Our Reference 141219

Client:
Trinity Grammar School

Response to Submissions Trinity Grammar School SSD 10371

Built form and Heritage

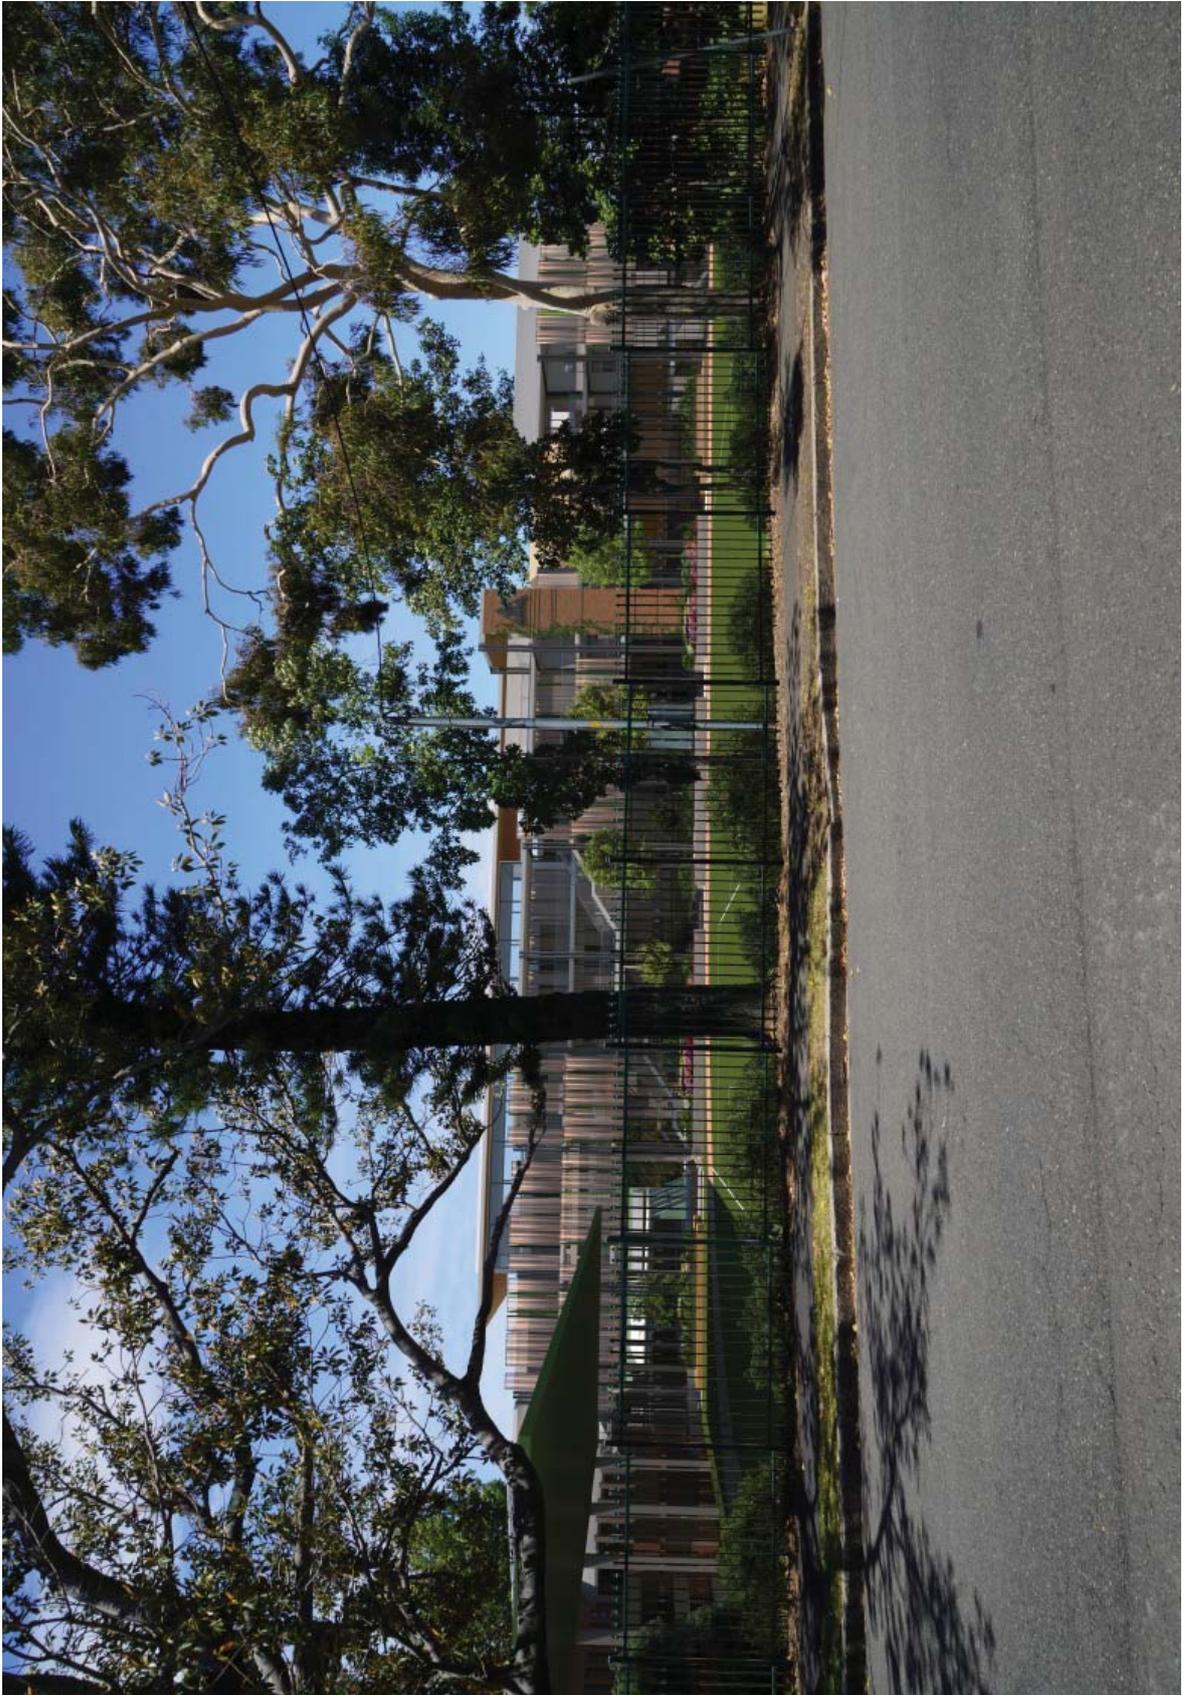
Position V3: Victoria Street adjacent to No.153

The proposed modified design is better articulated as a result of the lowering of the roof level. The bulk of the upper level is reduced.

The character, quality, materiality and general appearance of the development remains the same.

The comparison graphic shows the roof line of the existing application as a red, dashed, line, in comparison with the proposed modified design.

Position V4

The proposed modified design is better articulated as a result of the lowering of the roof level. The bulk of the upper level is reduced.

The character, quality, materiality and general appearance of the development remains the same.

The comparison graphic shows the roof line of the existing application as a red, dashed, line, in comparison with the proposed modified design.

The proposed modified design is subtly but detectably different from the existing application, with reduced bulk at the upper level, reduced height and greater articulation.

However, the proposed modification do provide a perceivable reduction in bulk of the upper levels of the development and a minor improvement to the apparent articulation of the proposal on either side of the lift core.

- Reduction in height of the Level 5 roof of the Teaching and Learning Block by 500mm and of its mechanic enclosure by 400mm.
 - The original proposed RL to the top of the Teaching and Learning Block was RL69.30. The proposed amended design drops the level to RL68.80.
 - The original proposed Mechanical Plant enclosure was RL68.60 and is now proposed at RL68.20.
-
